MEETING:	PLANNING AND REGULATORY COMMITTEE
DATE:	3 February 2021
TITLE OF REPORT:	<p>193878 - APPLICATION FOR APPROVAL OF RESERVED MATTERS FOLLOWING OUTLINE APPROVAL P141964/O (SITE FOR RESIDENTIAL DEVELOPMENT OF UP TO 90 DWELLINGS WITH ACCESS, PARKING, PUBLIC OPEN SPACE WITH PLAY FACILITIES AND LANDSCAPING). AT LAND OFF KINGSTONE ROAD, CLEHONGER, HEREFORDSHIRE.</p> <p>For: Engie Regeneration Ltd and Stonewater Developments Ltd per Miss Kate Holden, First floor, South Wing, Equinox North, Great Park Road, Almondsbury, BS32 4QL</p>
WEBSITE LINK:	https://www.herefordshire.gov.uk/info/200142/planning_services/planning_application_search/details?id=193878&search-term=193878
Reason Application submitted to Committee – Applicant is a Council Development Partner

Date Received: 7 November 2019 Ward: Stoney Street Grid Ref: 344626,237646

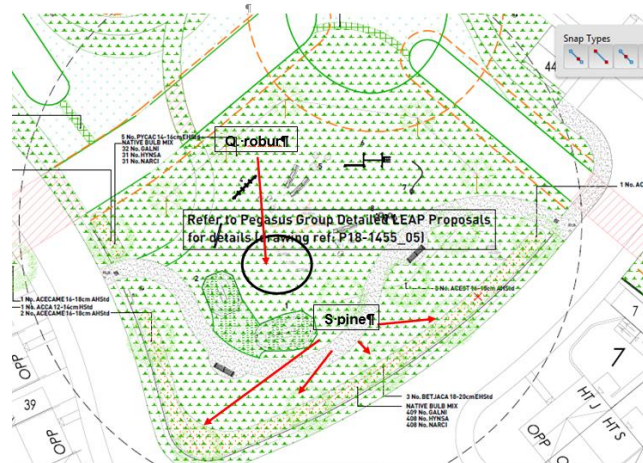
T6 – Tree Protection Plan and Proposed & Planning Layout show that the access road will extend into the rooting area by approximately 7m which in my opinion is too excessive, especially when drainage routes will also be sited under the road.

Any excavations required for drainage will, if not undertaken using trenchless methods, require the severance of a significant amount of roots which I would consider to be unacceptable.

It would be ecologically beneficial if T1 & T6 were linked by the green space. The current proposals separate them with the access road which I have expressed reservations for.

I request amendments are made to the plan so the layout in the eastern corner of the site has a reduced impact on the trees T1 & T6.

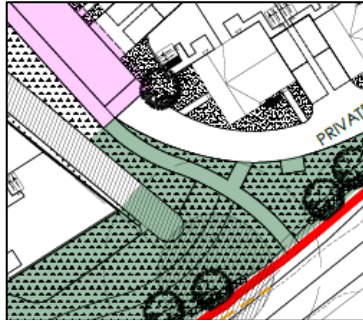
Further to the previous highways comments on this application the majority of the issues raised have been addressed by the recent document submission. The following comments relate only to the outstanding comments on the layout.

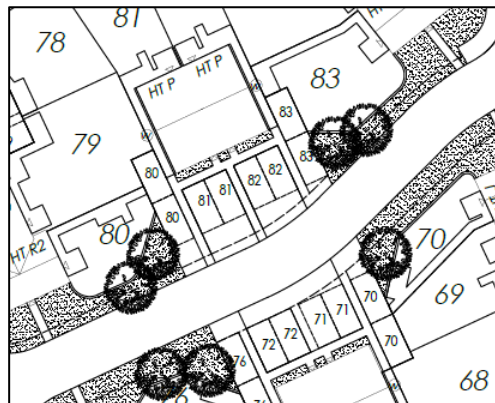
The S278 (offsite) elements of the access strategy have been considered and the way that these links interact with the layout and the proposal is acceptable. The key point here is the link that extends from the area around plot 57 to the existing footway is suggested as unadoptable. This is not the case and the LHA consider this route as both adoptable and of particular importance in providing direct walking routes from the site to the amenities of Clehonger. As a result this route could be shaded pink on the adoption plan. For clarity this route is extracted below.
